M9018A-03A

Information Only Service Note

M9018B PXIe Chassis: 18-slot, 3U, 8 GB/s

System not being able to enumerate PXI modules due to code 10 errors under Device Manager for PCI Express to PCI/PCI-X Bridge when use with M9025A.

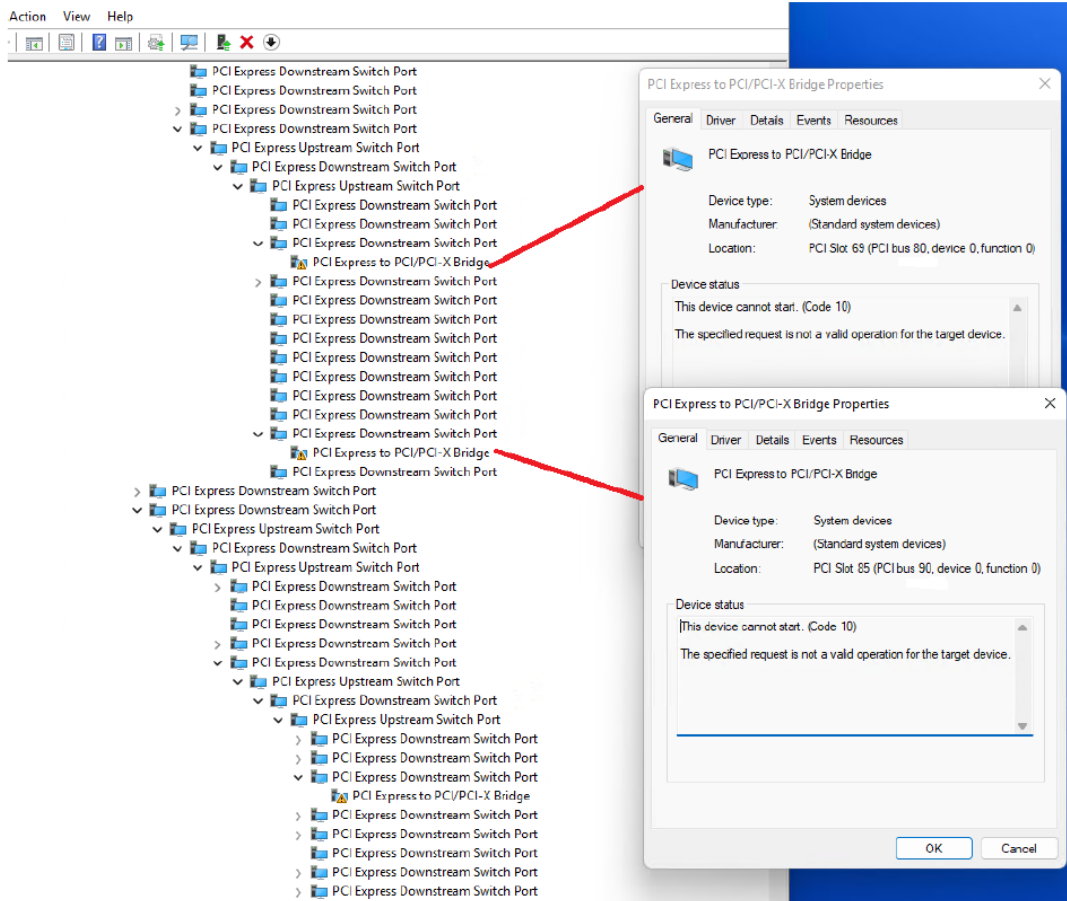
It has been found when the affected chassis are used with M9025A PXIe Thunderbolt System Module that the Device Manager would encounter code 10 errors under the PCI Express to PCI/PCI-X Bridge like picture below. This results in the system not being able to enumerate PXI modules in the chassis.

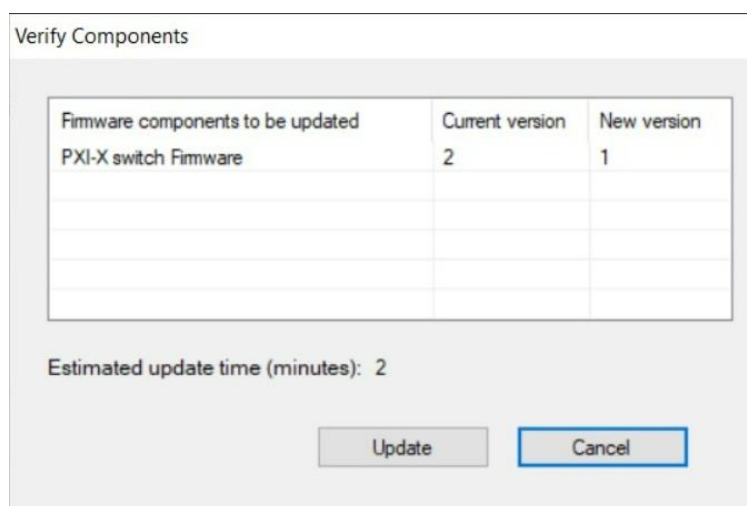
If you run into code 10 errors under Device Manager for PCI Express to PCI/PCI-X Bridge when used with M9025A in non-affected Keysight PXIe Chassis from table above, follow the steps below to resolve the code 10 errors at the PCI Express to PCI/PCI-X Bridges.

1. Install drivers version 1.7.1032.1 or later at the chassis product website <http://www.keysight.com/find/M9018B>, navigate to Technical Support > Drivers, Firmware and Software > PXIe Chassis Family Drivers.
2. After updating the drivers, run the update FW tool at the chassis product website <http://www.keysight.com/find/M9018B>, navigate to Technical Support > Drivers, Firmware and Software > Chassis Firmware.
 - a. When the *.bin file is run, it will detect the PXI-X switch Firmware needing to be updated like picture below. Press Update to update.

- b. Cycle power the chassis after the update is done and the code 10 errors should be cleared.
